Charlotte-Mecklenburg Planning Department

SUBJECT: Administrative Approval for Petition No. 1998-042C Erwin Capital and The Crosland Group.

LANDSCAPE PLAN
BP STATION BEAVER FARMS LOT 7
10950 WOODLAND BEAVER RD
CHARLOTTE, MECKLENBURG COUNTY, NORTH CAROLINA

NEW CONVENIENCE STORE AND CARWASH FOR
MARK OIL: BEAVER FARMS BP
 10950 WOODLAND BEAVER ROAD
 CHARLOTTE, NC

SHEET
A-3
 OF
 13

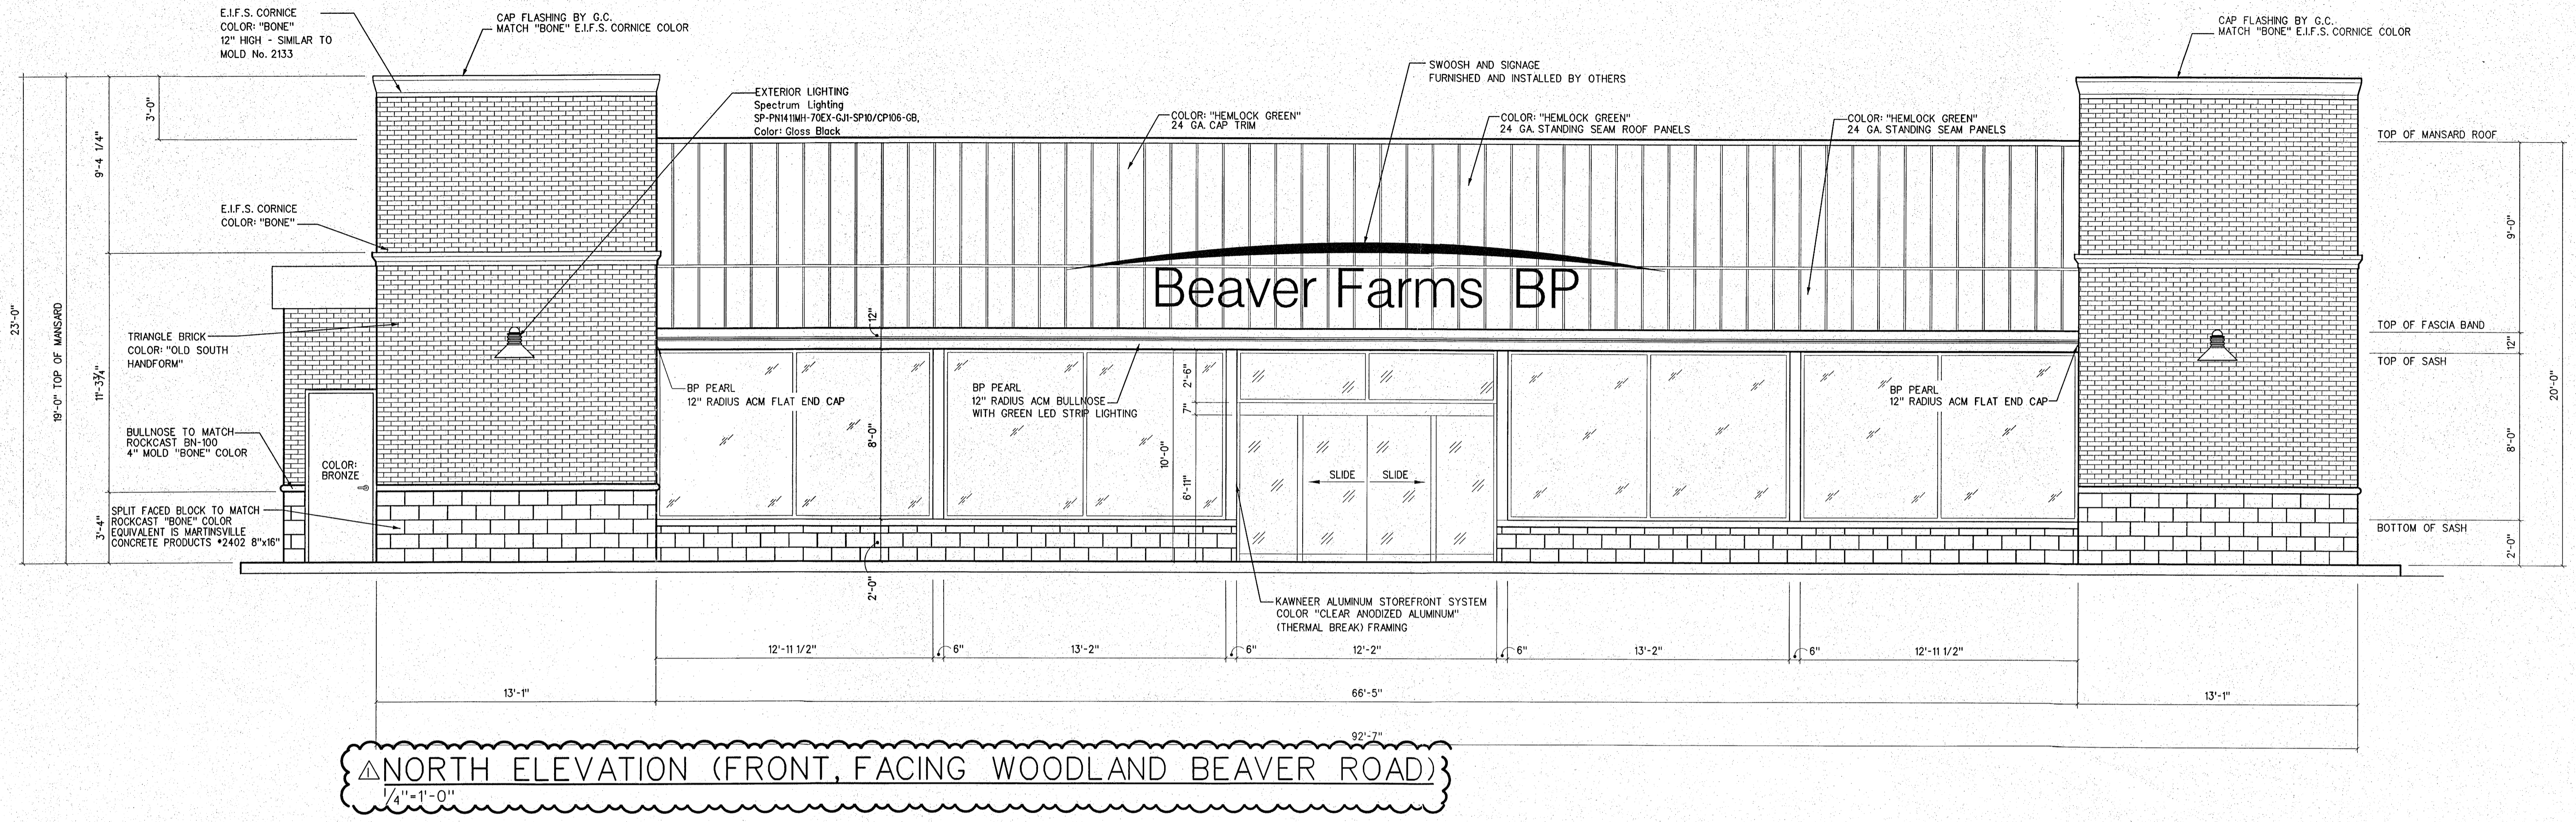
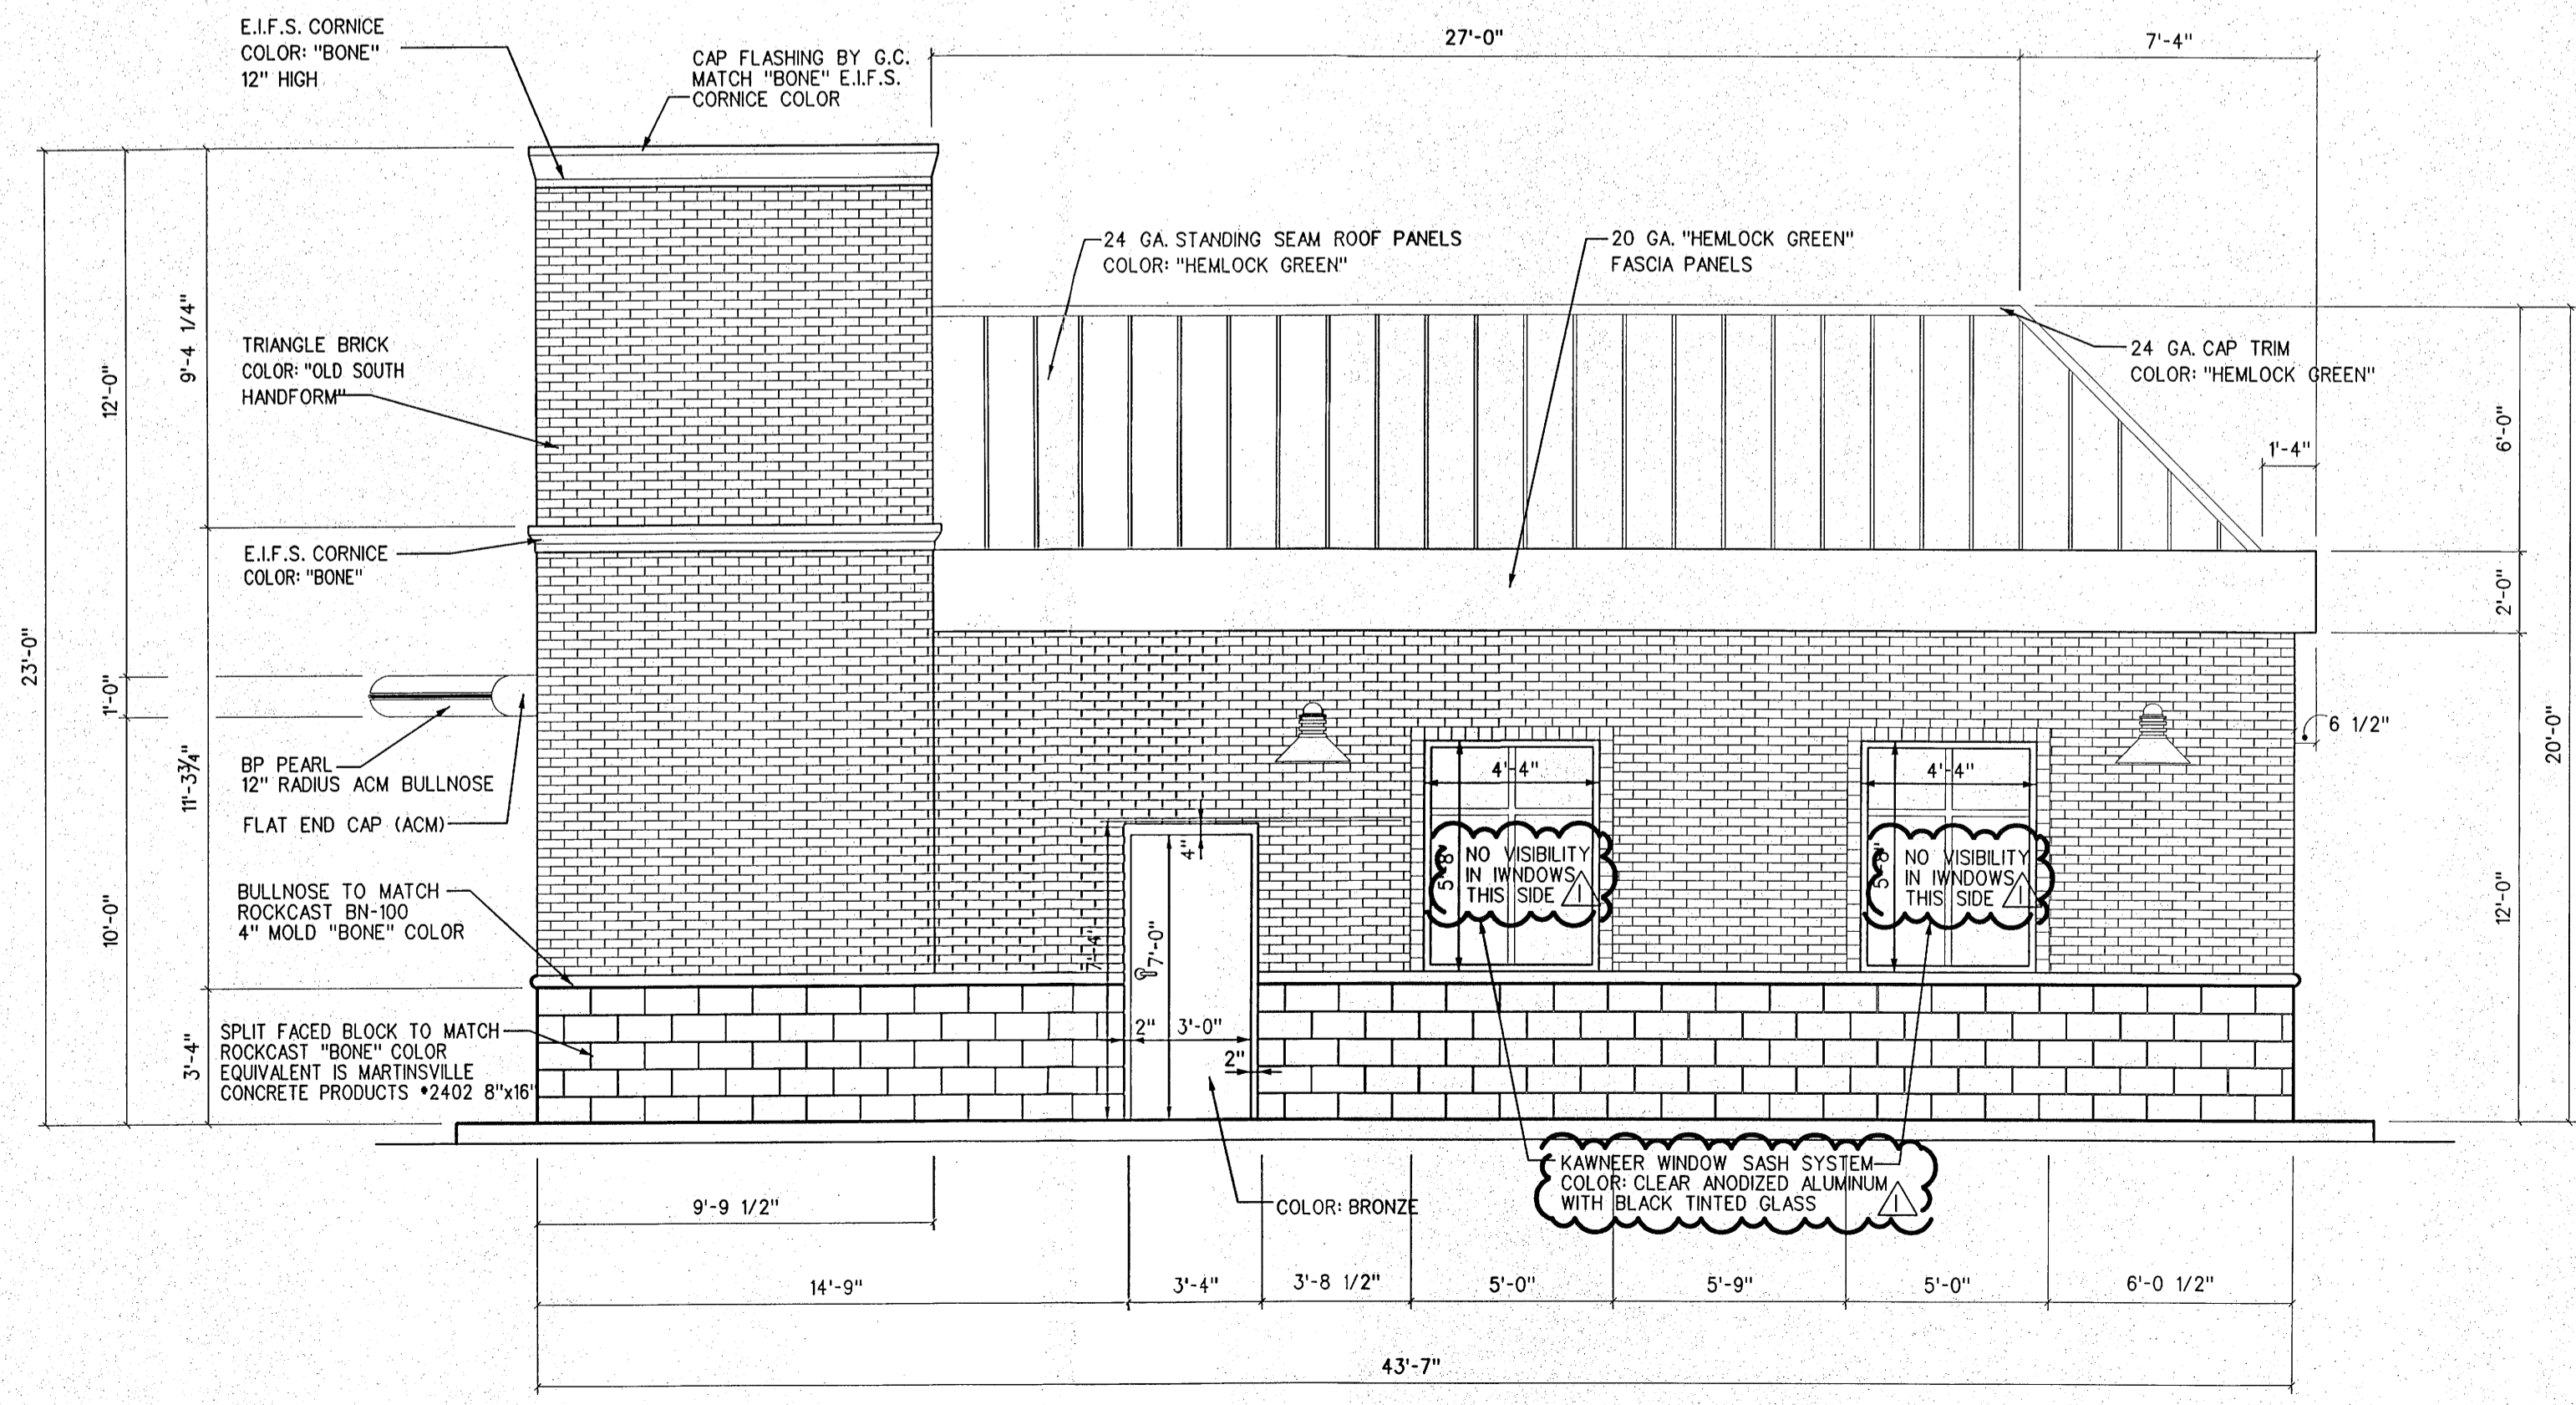
- Proposed building elevations for the proposed convenience store with accessory pumps.
